**PREVOST**

SAFETY RECALL

SR13-73

DATE :	DECEMBER-2013	SECTION :	06 - Electrical
SUBJECT:	P-Clamp on Bosch T1 alternators

Fig.3 Details of the P-Clamp installation on the lower BOSCH T1 alternator

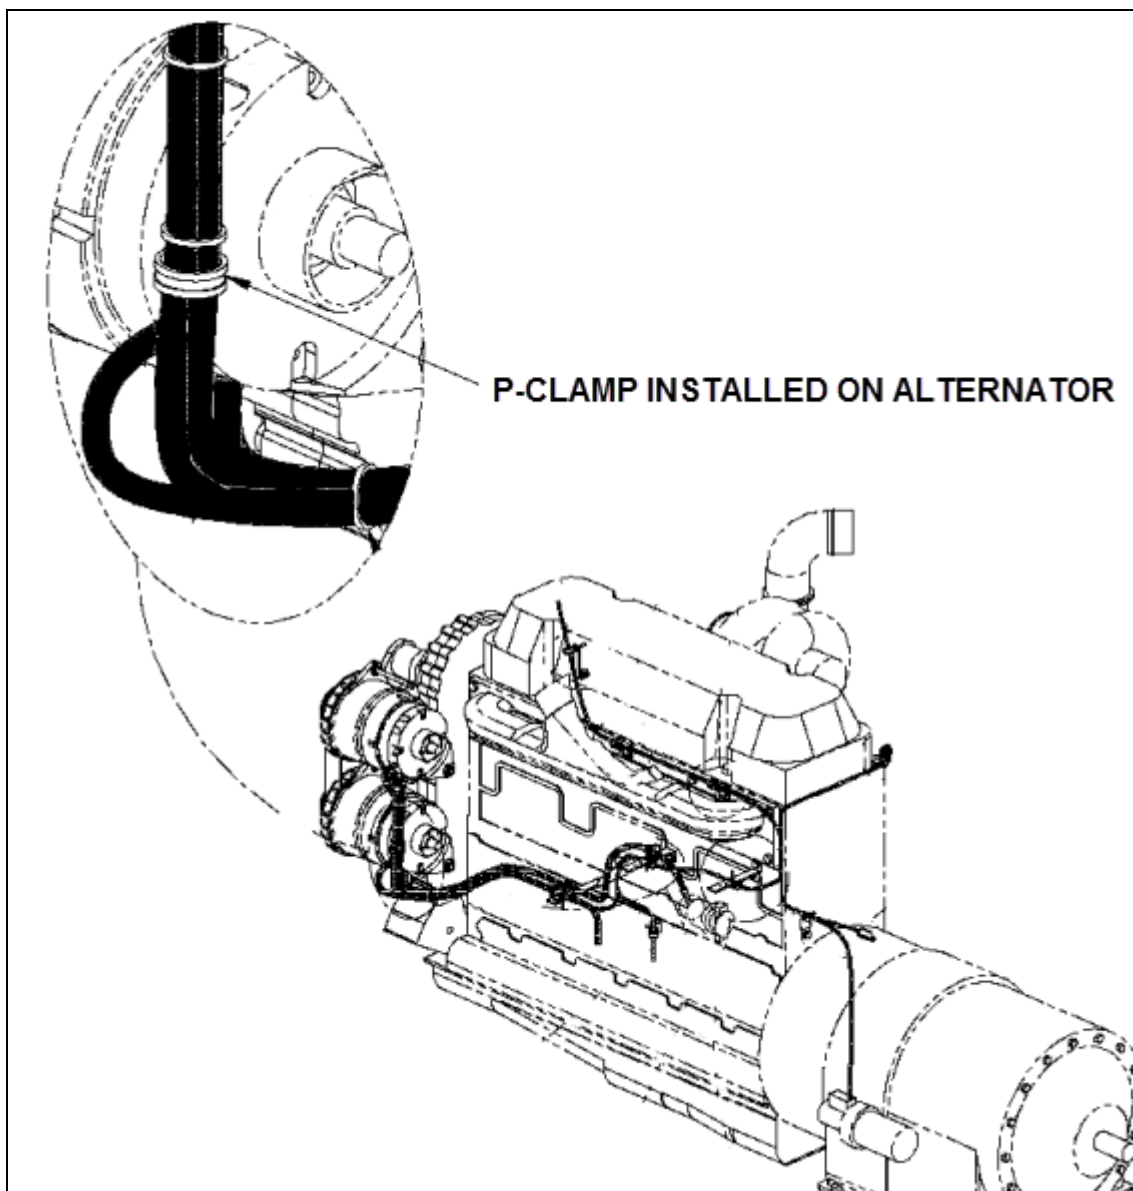
On vehicles affected by this recall, a P-Clamp may have been installed at the back of the lower alternator to hold one of the two (2) power cables coming from the upper alternator.

Since these cables run in close proximity of each other and that only one of the cables runs through the clamp, the other cable may rub against the P-Clamp which over time may result in abrasion of the cable insulation and cause a short circuit.

2. Access the rear of the alternators and check for P-clamps fixed directly to the back of the alternator bodies (Fig.3 and 4).

NOTE: In the majority of the vehicles affected by the problem, the P-clamp will be positioned on the top left corner (viewed from the back of the alternators) of the lower alternator (Fig.3 and 5) Nevertheless, inspect both alternators.

To prevent this situation, *all* P-Clamps found on the alternators bodies (upper or lower) must be removed and the power cables secured to the adjacent electrical harness.

3. Unscrew and discard *all* P-clamps found on the alternator bodies (If none were found, make sure all cables are secured as per step 4 below).
4. Using nylon cable ties, secure the cable(s) removed from the P-clamp (and all loose wires) to the vehicle power harness.

Fig.6 Upper alternator cables secured together

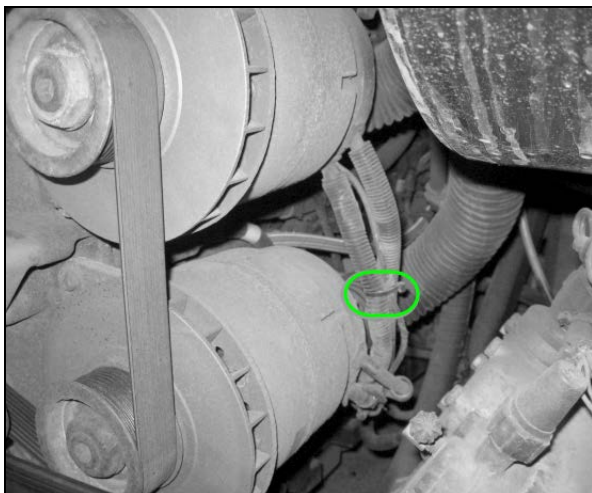
NOTE: Secure as much as possible *all cables* coming from the alternators to the main harness as shown on fig.6 and 7 below.

Fig.8 Power cables going to the starter motor

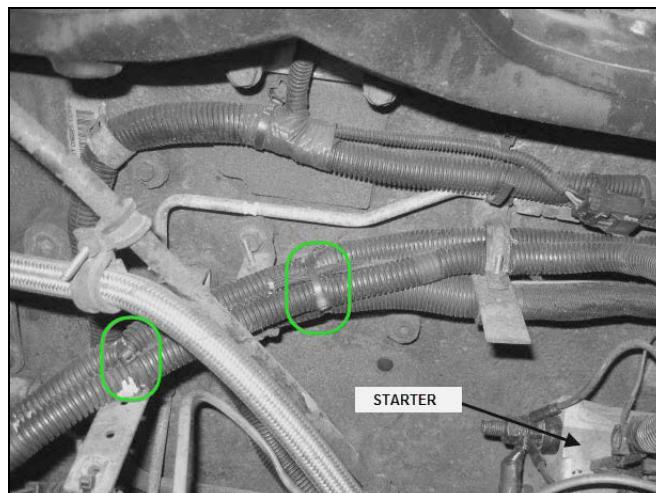
Moreover, it is recommended to inspect the complete electrical harness coming from the two alternators up to the starter motor and make sure that all cables are securely tied to each other such that they do not rub against any parts of the vehicles.

5. Make sure that the cables are correctly secured all the way to the starter unit. Ad cable ties as necessary (Fig.8)
